March 10, 2023

Project Name: PEARL JUNIOR HIGH MULTIPURPOSE
Project No: 22-056
RE: Updated Civil and Structural drawings.

ADDENDUM NO. 01

5 GRADE BEAM INTERSECTION - ALTERNATE 1
S300 3/8" = 1'-0"

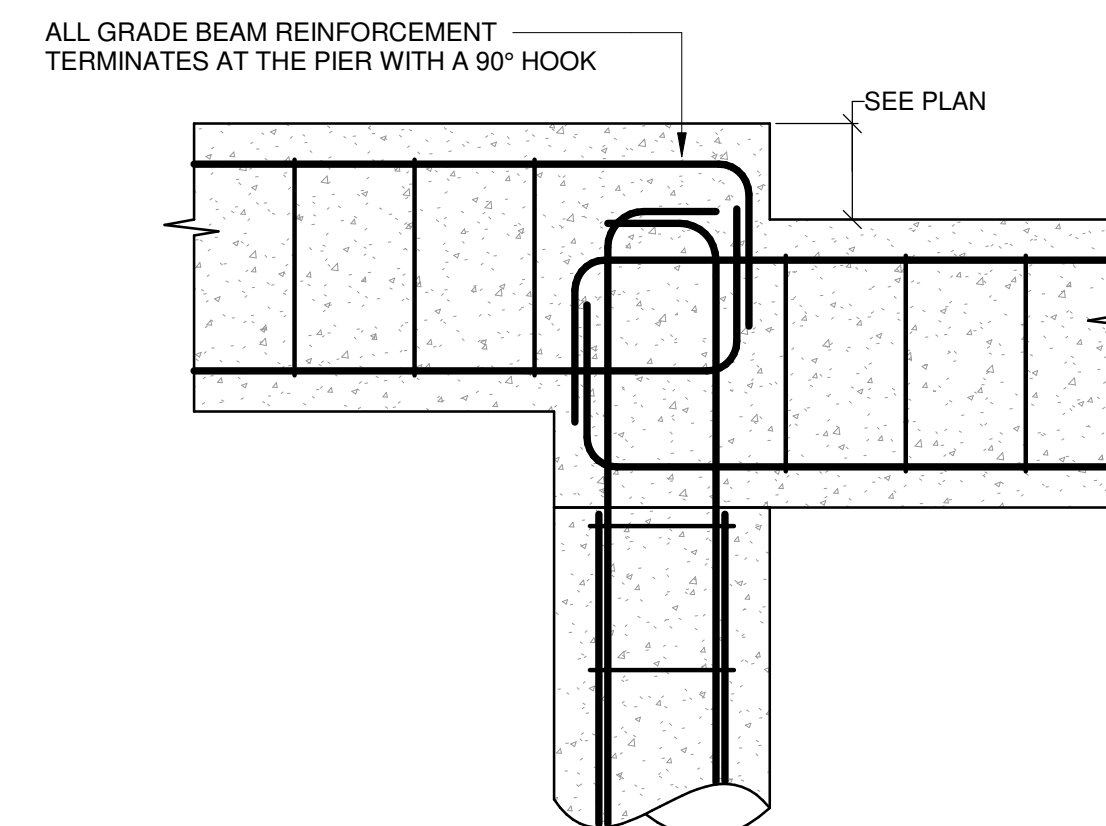
- S300 DETAILS
 - Modified top of slab level.
 - S301 DETAILS
 - Modified top of slab level.

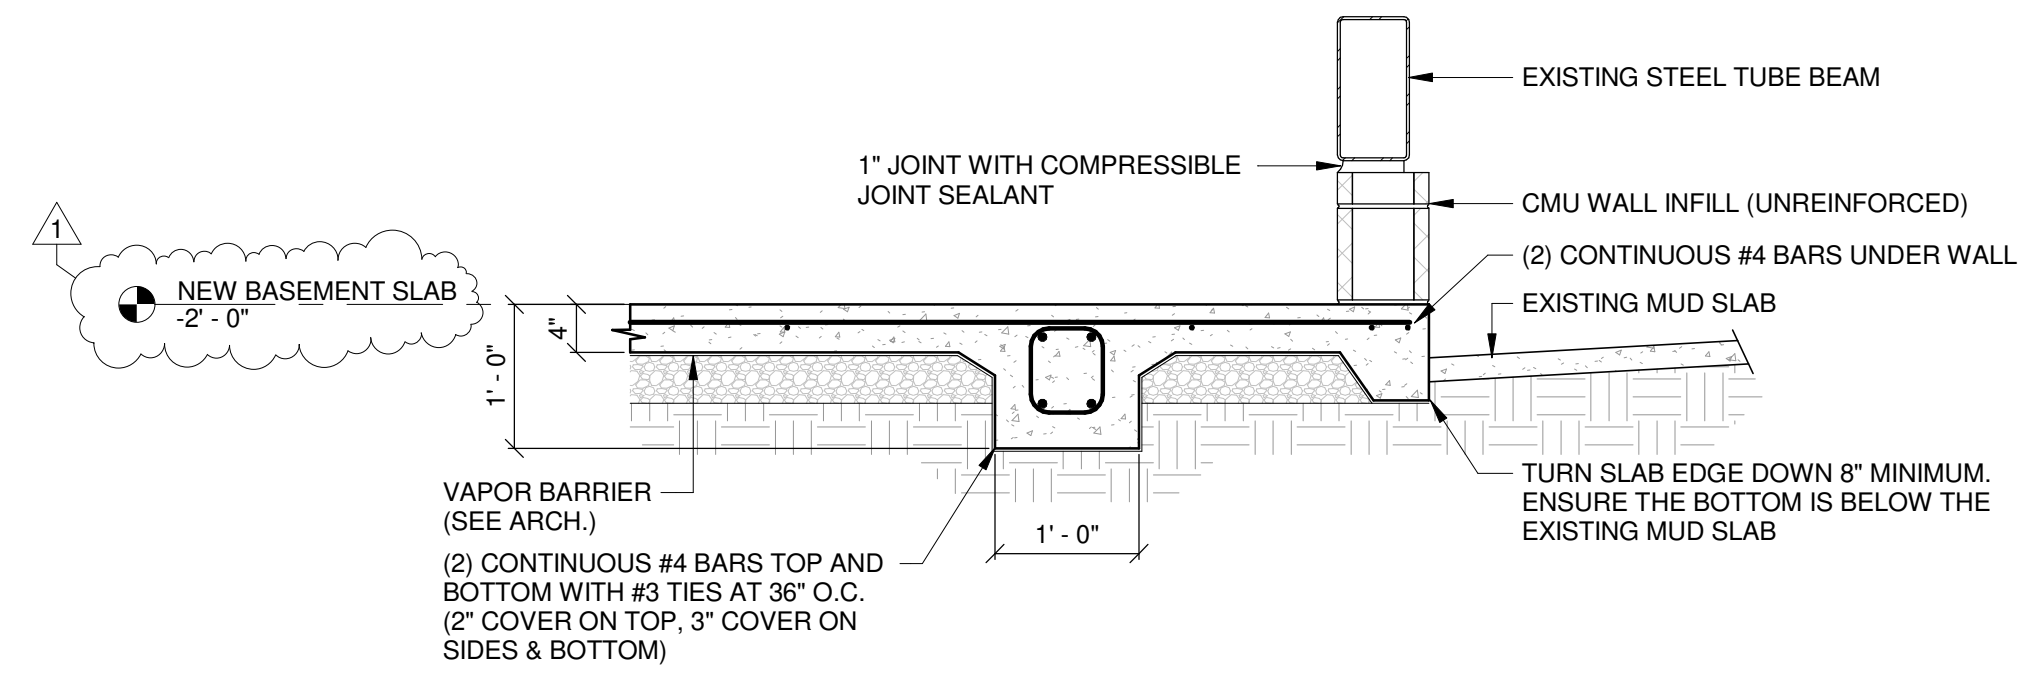
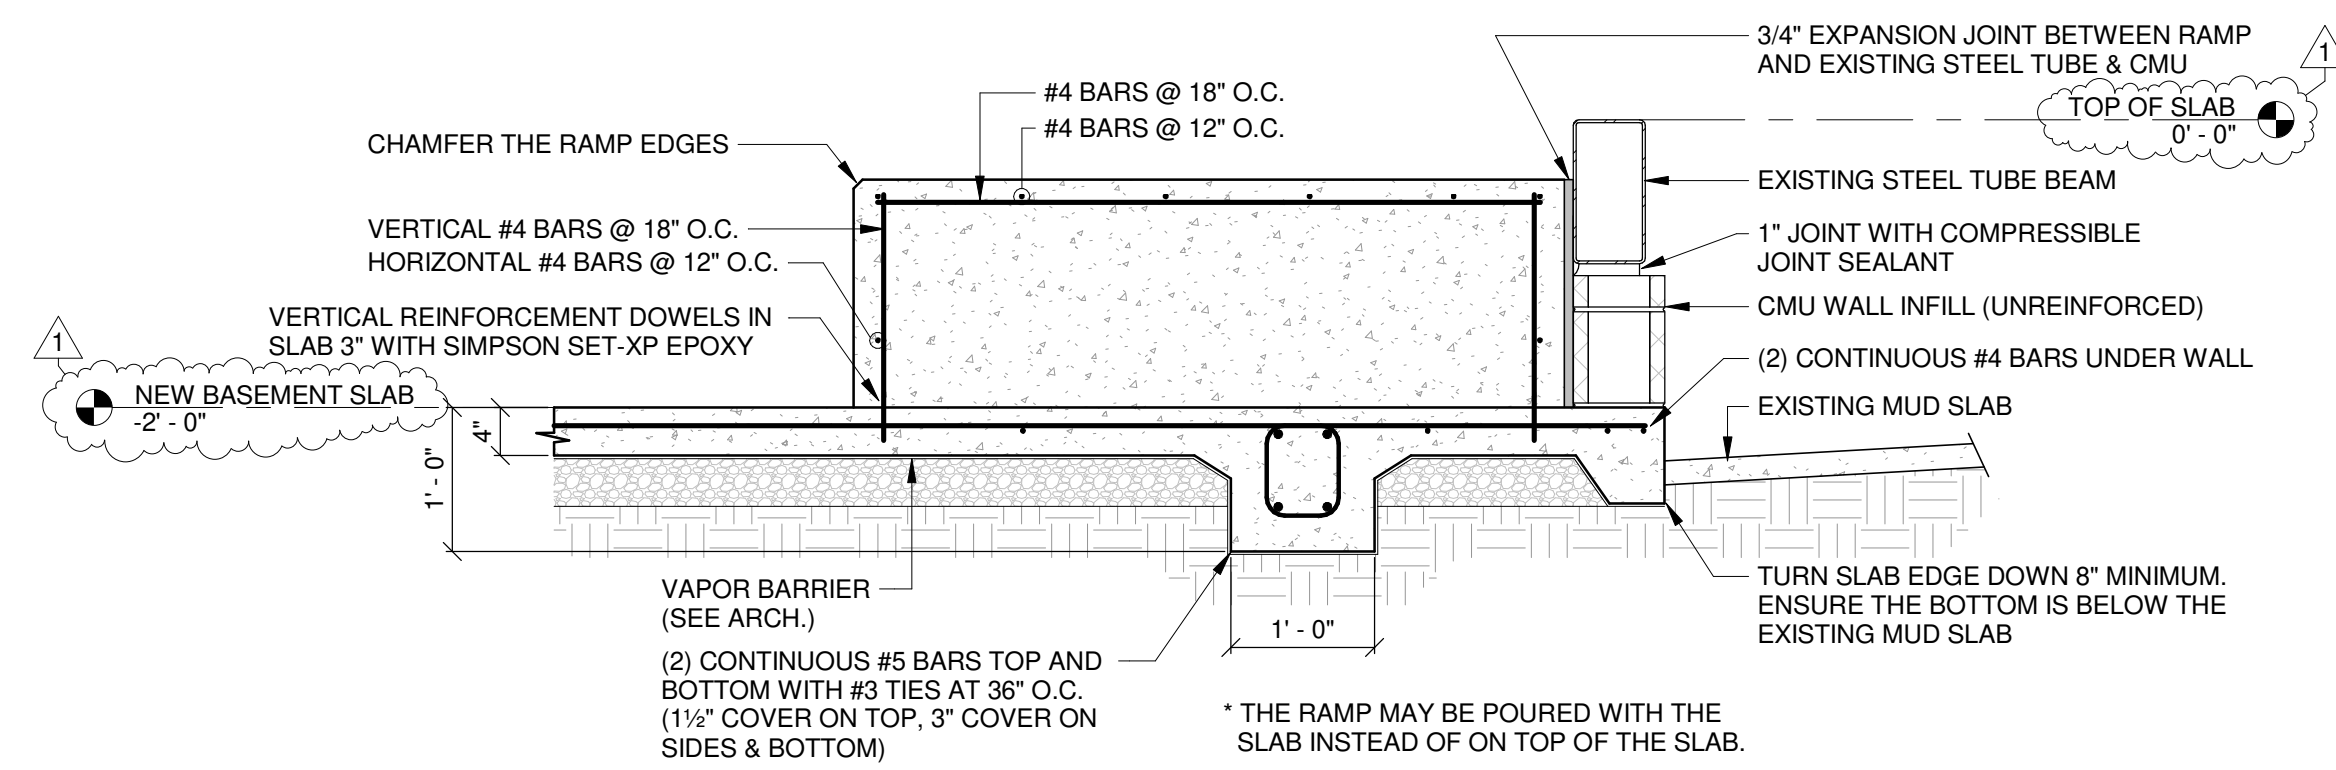
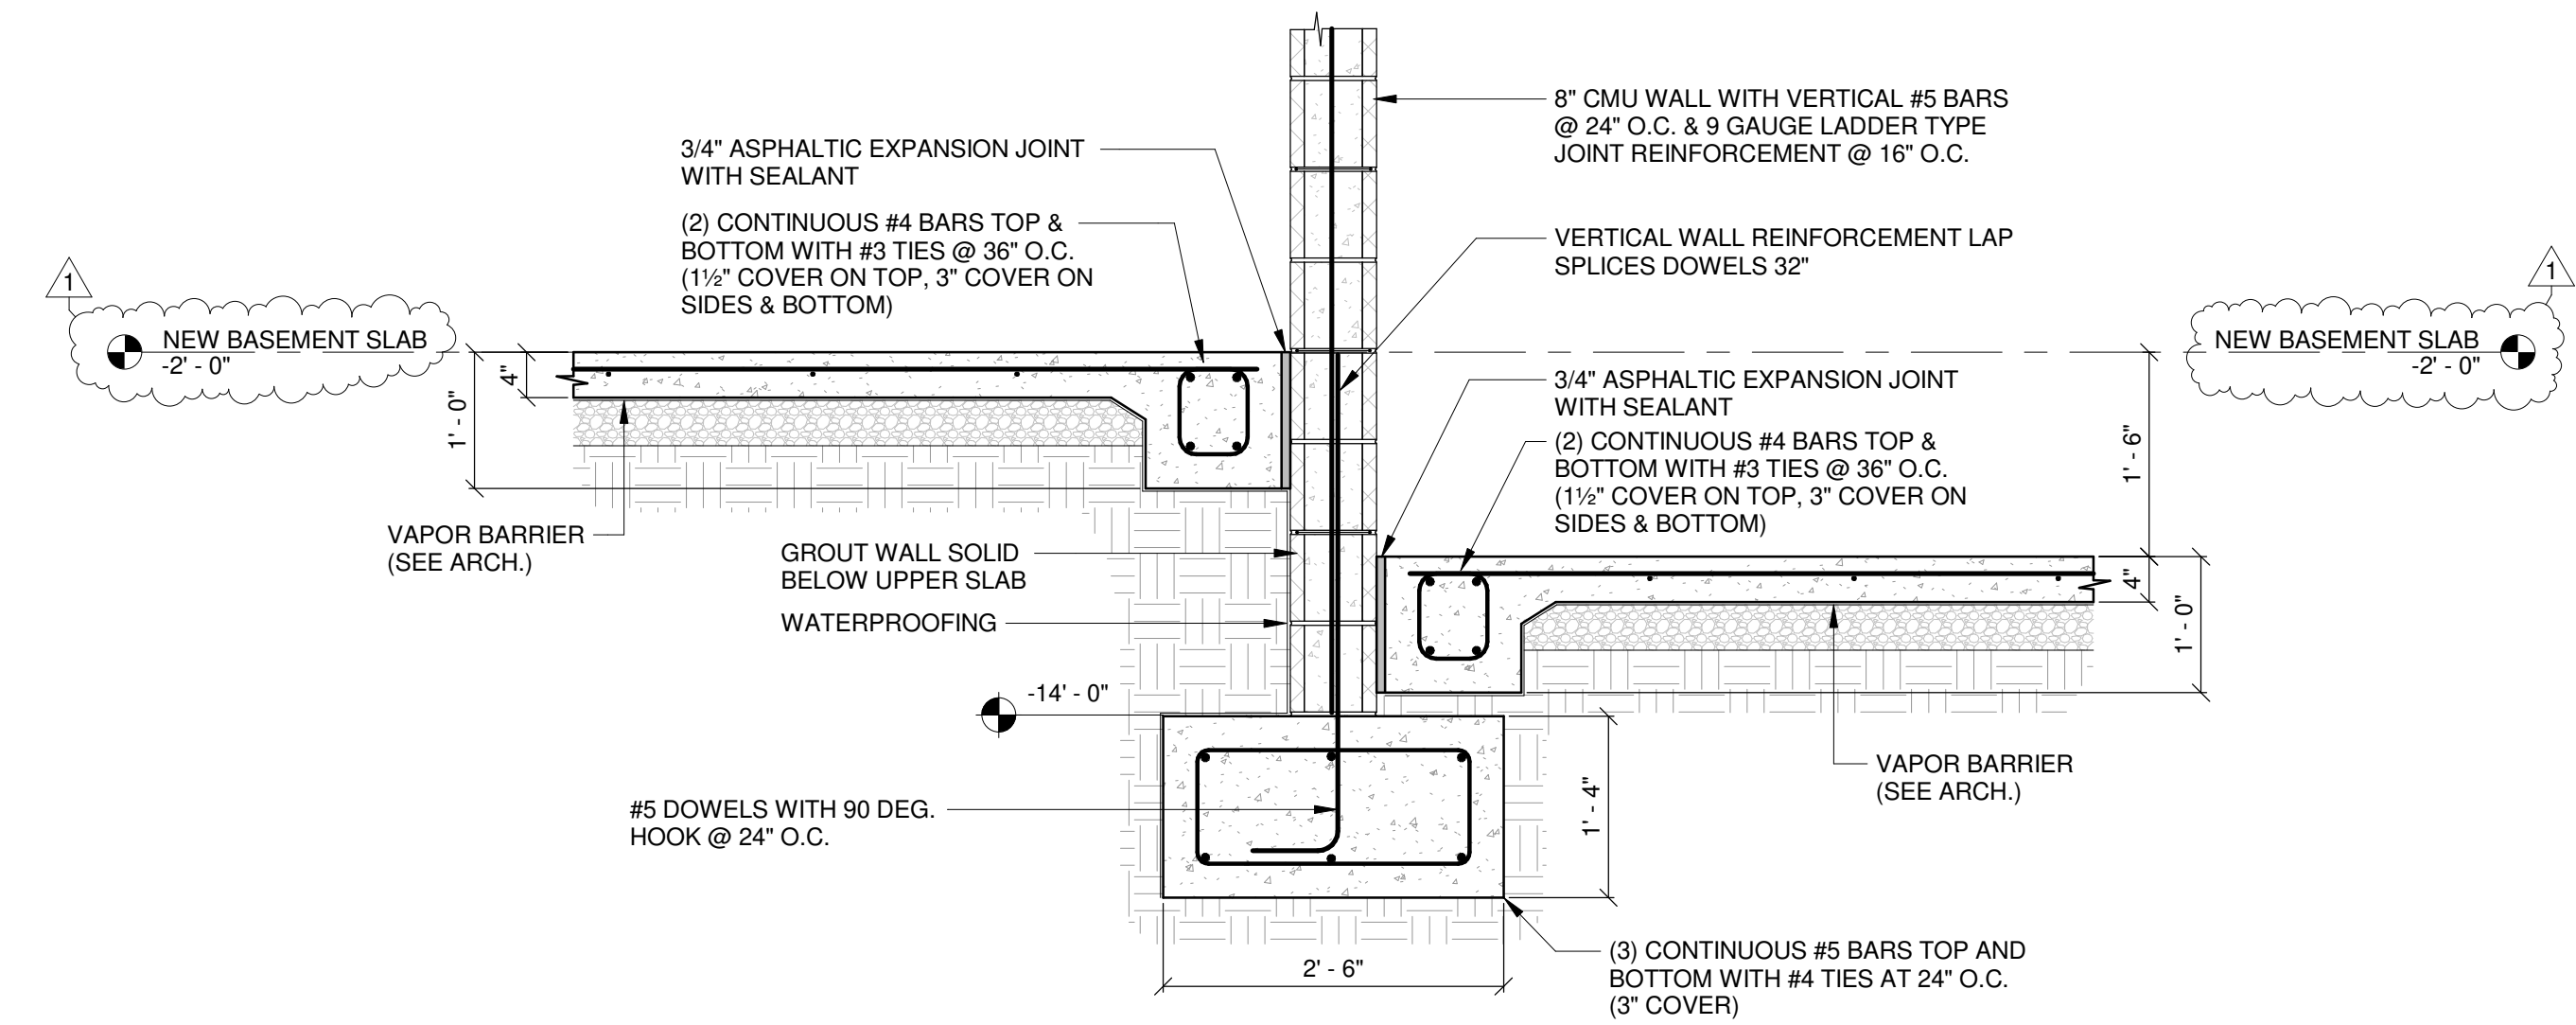
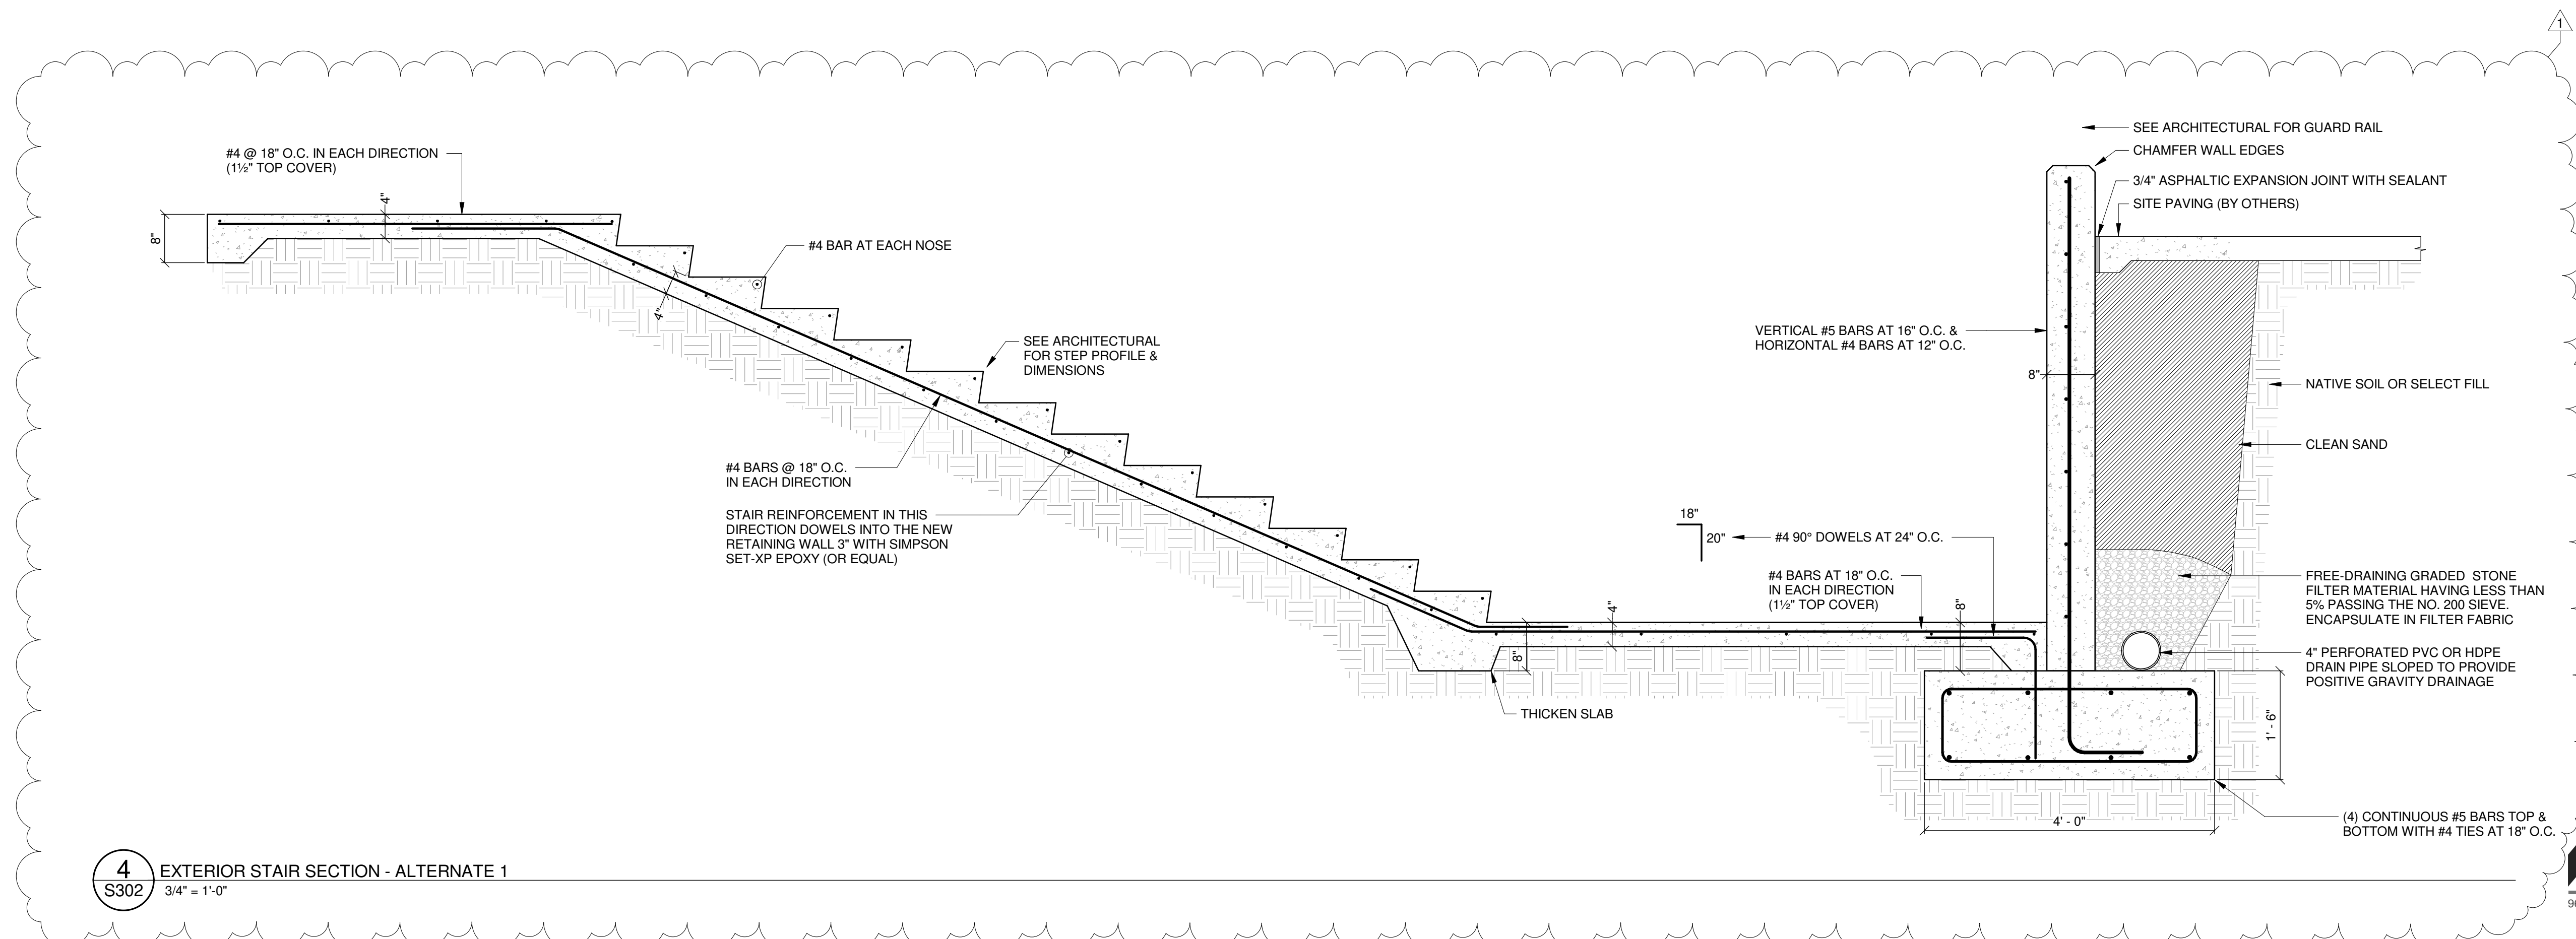
- S302 DETAILS
 - Modified top of slab level and exterior stair detail.
- S303 DETAILS
 - Added sections for mechanical screen wall.
- S304 DETAILS
 - Modified wall sections.
- S305 DETAILS
 - Modified details.
- A109 OVERALL ROOF PLAN
 - Modified the dimension of the mechanical screen.
- A402 INTERIOR DETAILS – ALTERNATE 1
 - Modified the spacing of the acoustical sealant.
